City of
Kelowna

TA24-0009

General Improvements to Zoning Bylaw

Text Amendments

Fencing & Retaining Walls

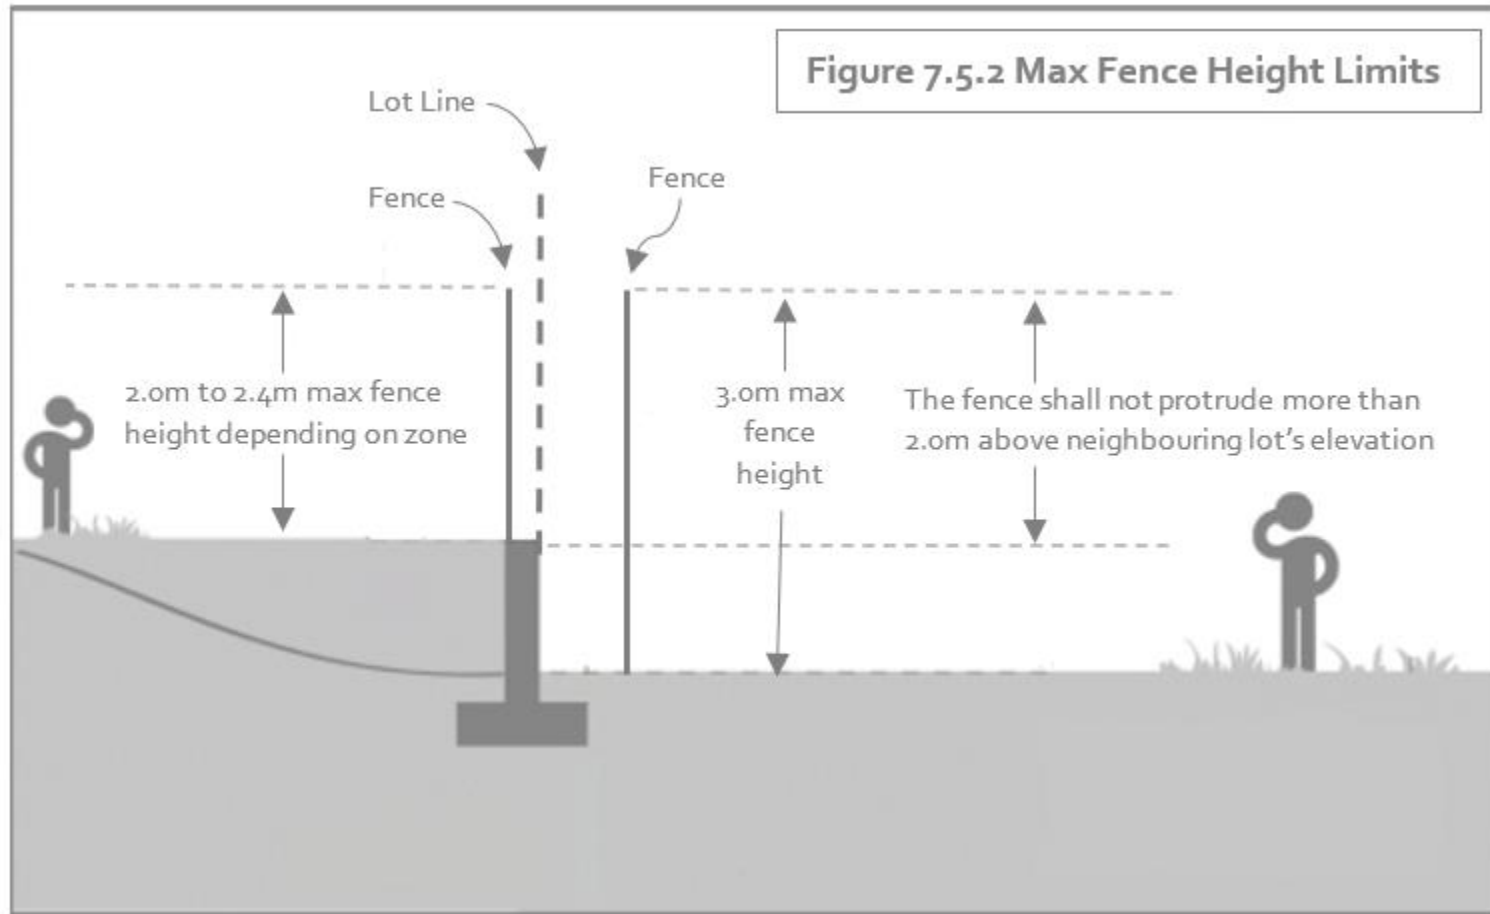
No.	Area of Change		Additional Detail
4.	Section 7 – Site Layout (Fencing and Retaining Walls)	Updates to: a) Formatting b) Fences on top of or beside retaining walls c) Retaining walls	a) Simplify and reorganize section into two separate sections (Fencing & Retaining Walls). b) Clarify the intended height of a fence on top of or beside a retaining wall or steep slope. c) Rewrite retaining wall section for increased clarity of maximum retaining wall height and when a professional engineer is required.

- 7.6.1 No individual **retaining wall** shall exceed a height of 1.2 metres measured from grade on the lower side.
- (a) Except, where the grade of the subject **lot** is lower than the **abutting** property then any **retaining walls** must not exceed a height of 3.0 metres measured from grade on the lower side.

- (b) Except, **retaining walls** can be any height subject to condition of **subdivision** approval.
- 7.6.2 Notwithstanding S.7.6.1; any individual **retaining wall** greater than 1.2 metres in height must be constructed with a professional design by a qualified professional engineer.

- 7.6.3 Notwithstanding S.7.6.1; any tiered **retaining walls** must be spaced horizontally a minimum of 1.2 metres between tiers. The maximum number of **tiers** that may be constructed without a professional design by a qualified professional engineer is two. The maximum total height of any retaining wall system that may be constructed without a professional design by a qualified professional engineer is 2.4 metres.
